25315 - BESD TREMONTON ELEMENTARY
2900 West 500 North Tremonton, UT

Addendum

ADDENDUM 001

Electrical Addendum #1

SHEET E116.3

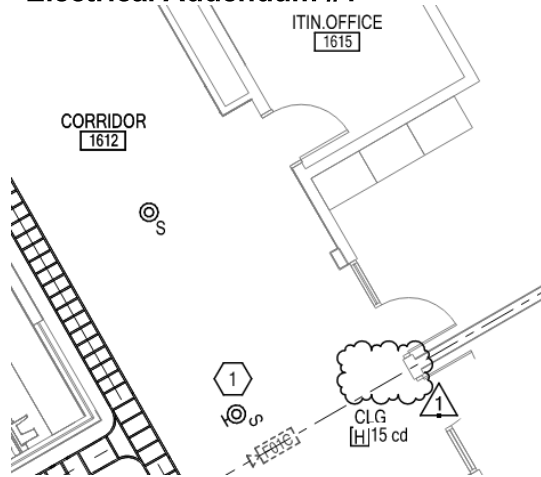
1. Wall mounted camera removed.

E001

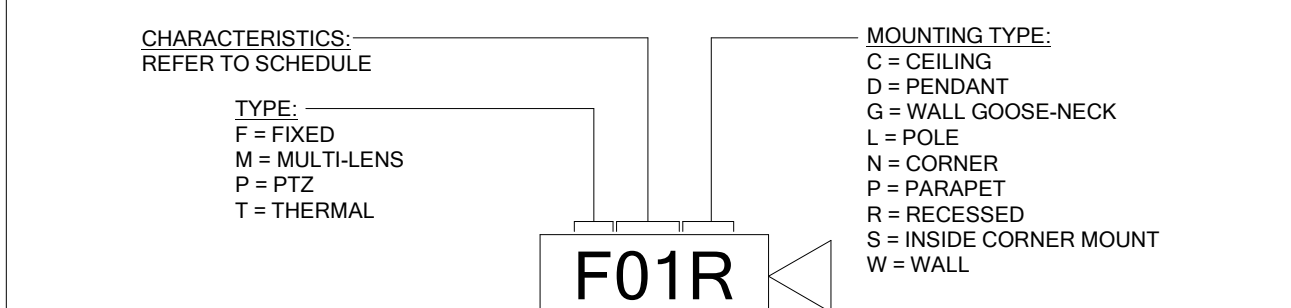
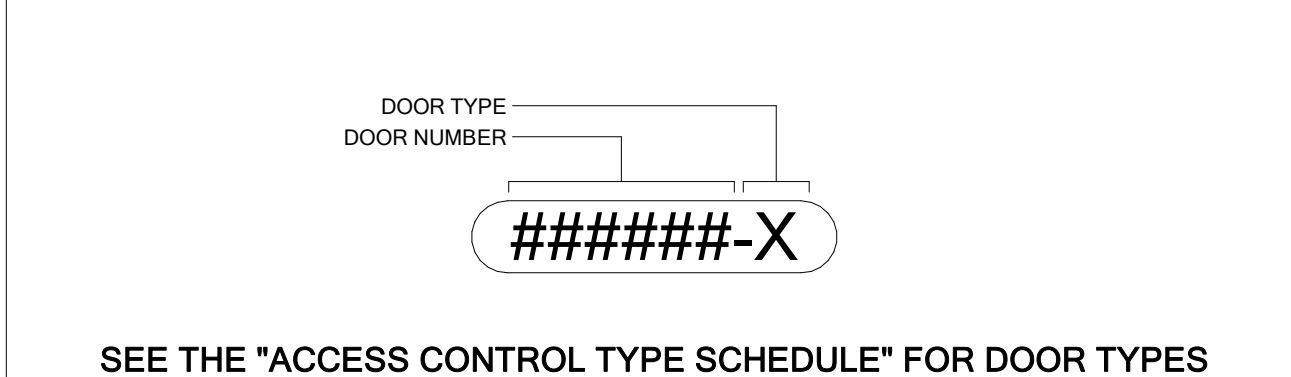
1. See clouded areas on sheet attached.

ET401

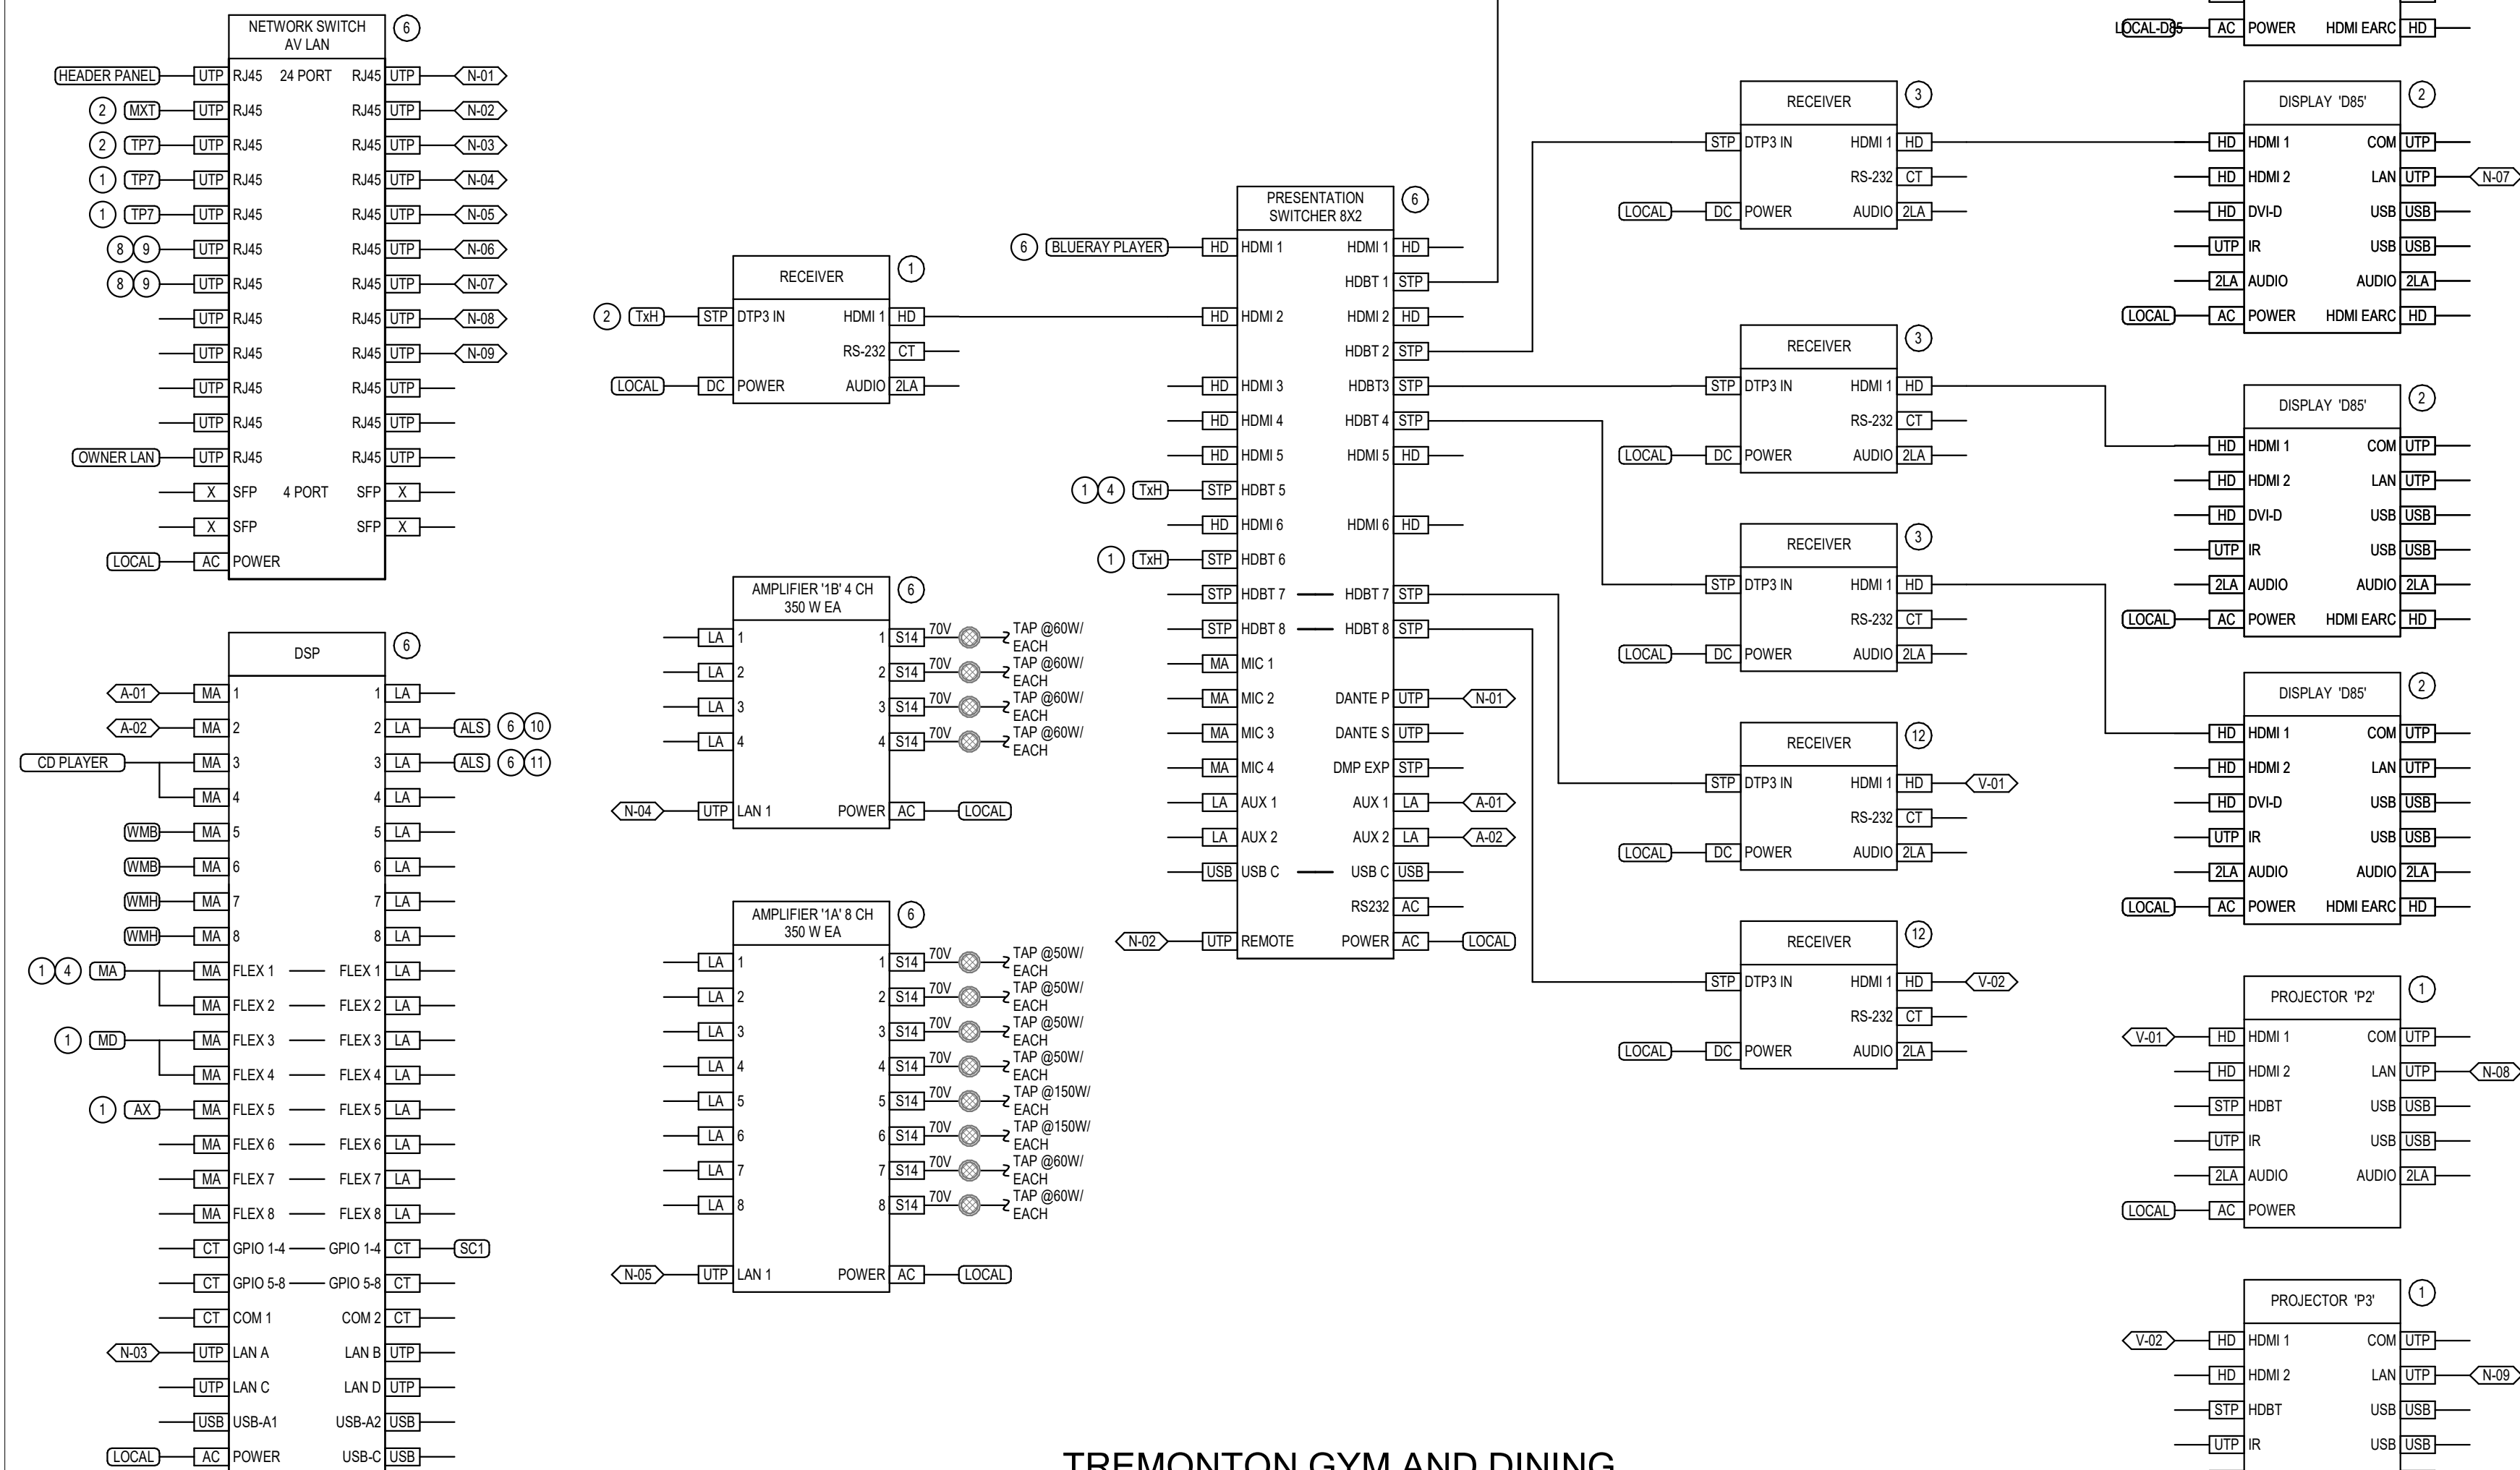
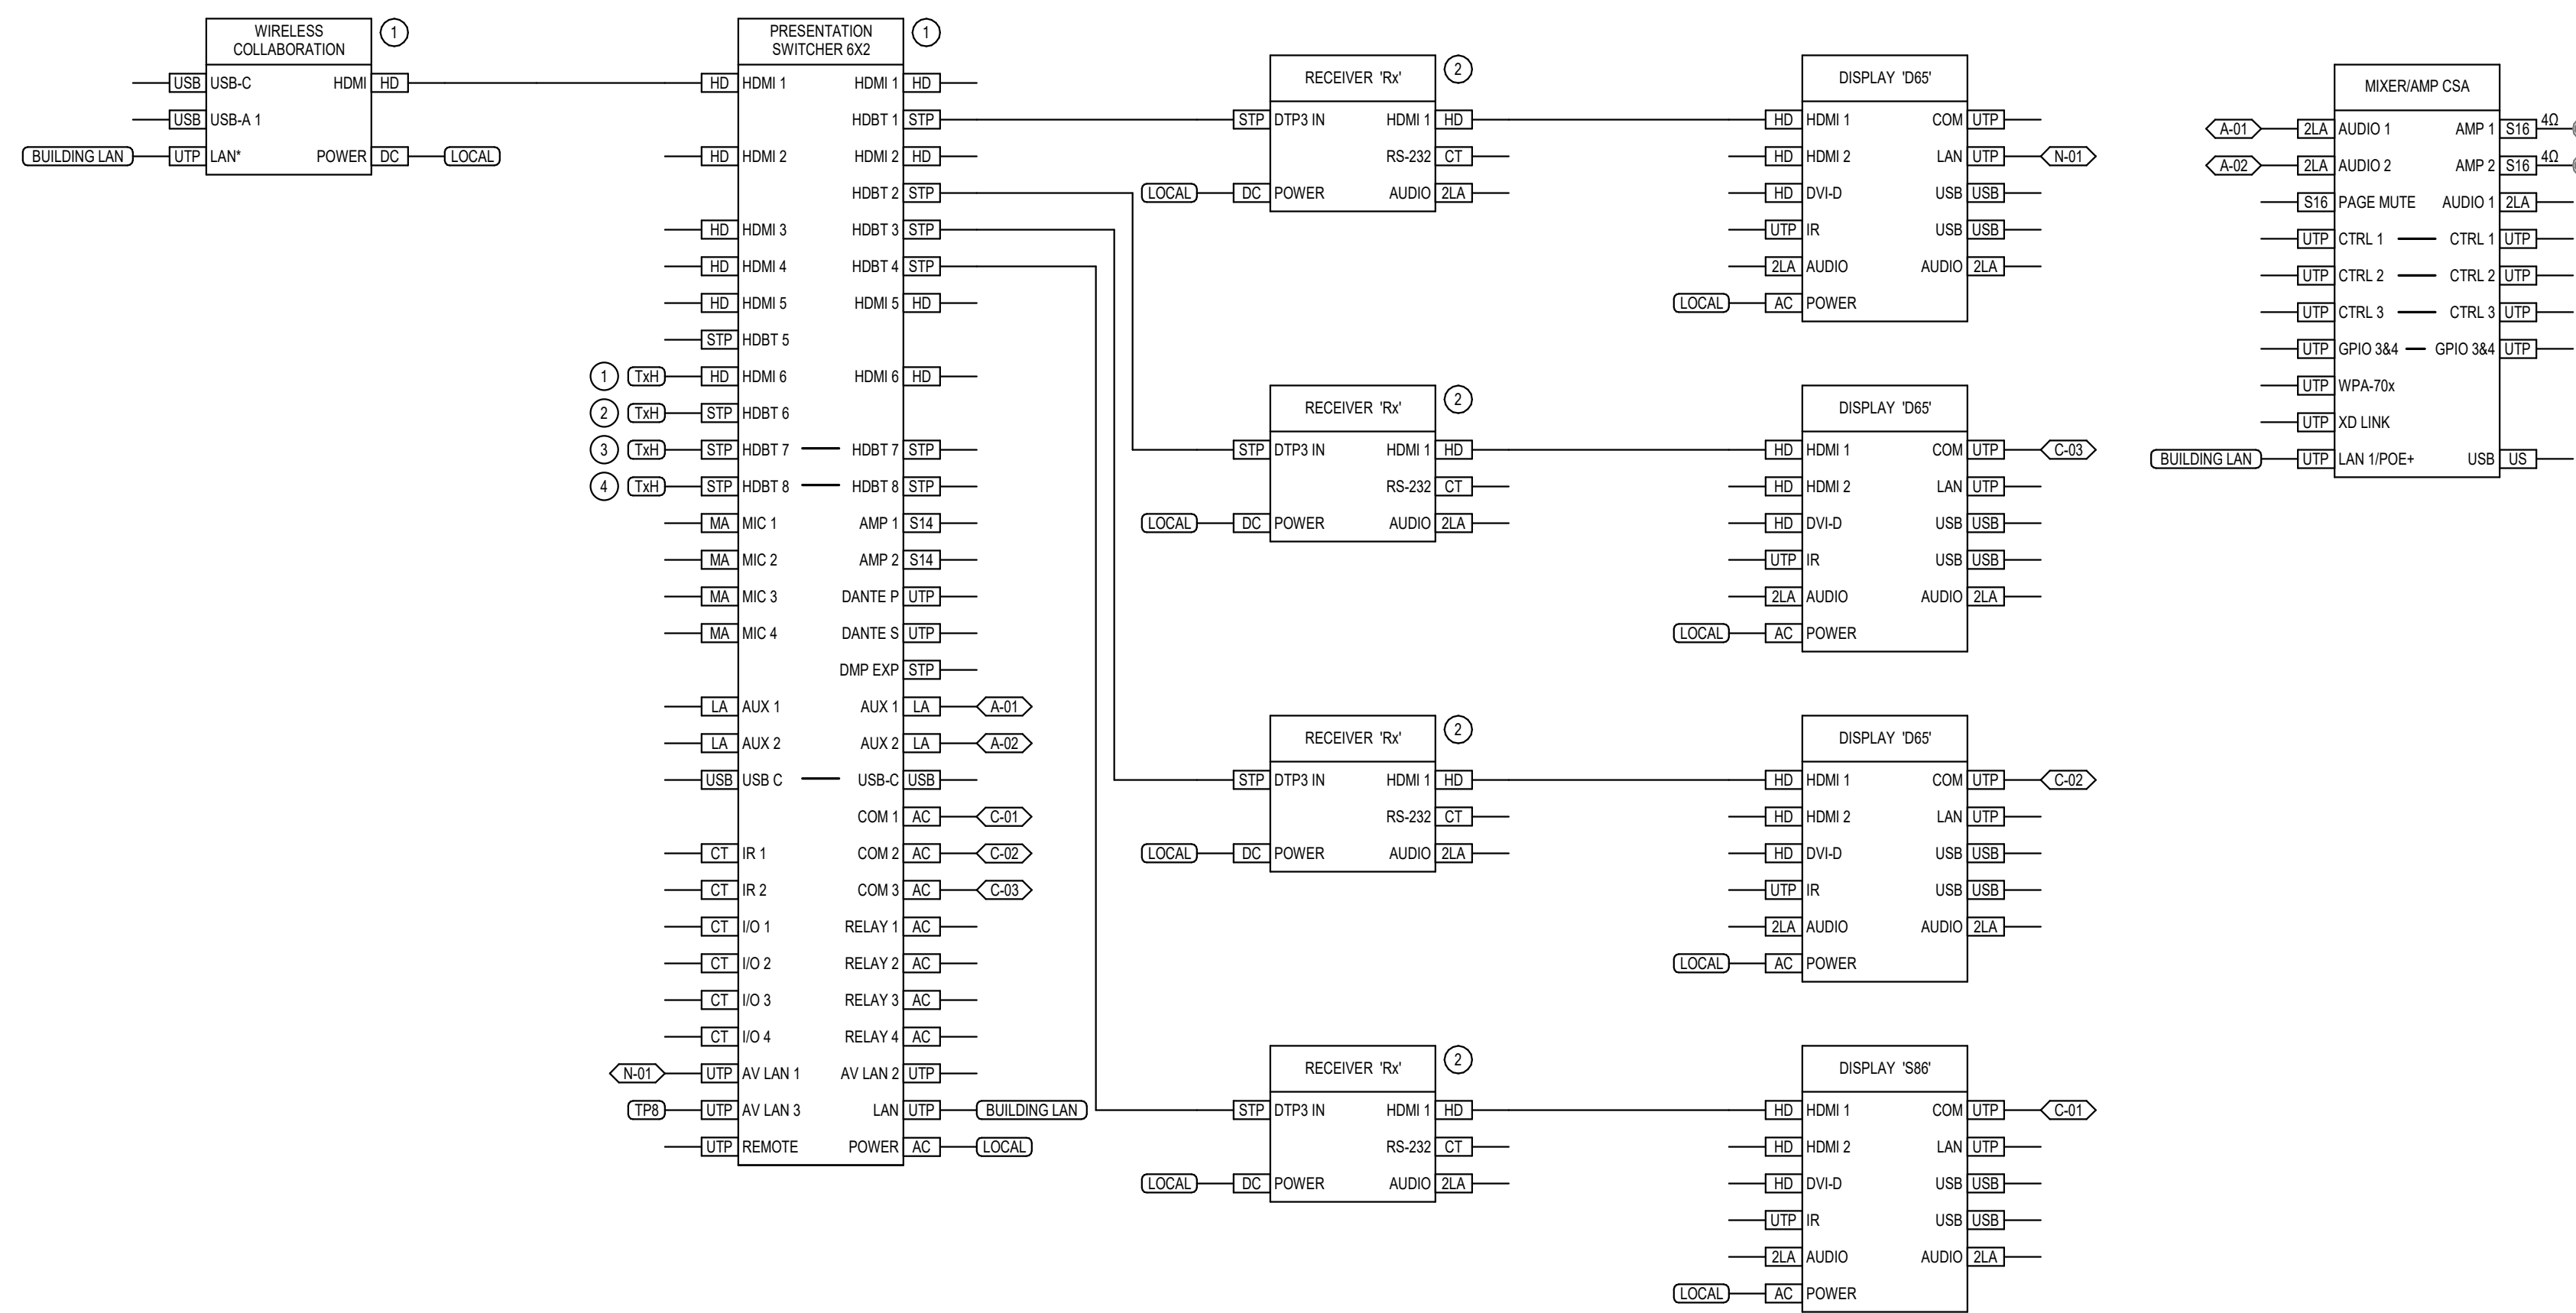
1. See clouded areas on sheet attached.
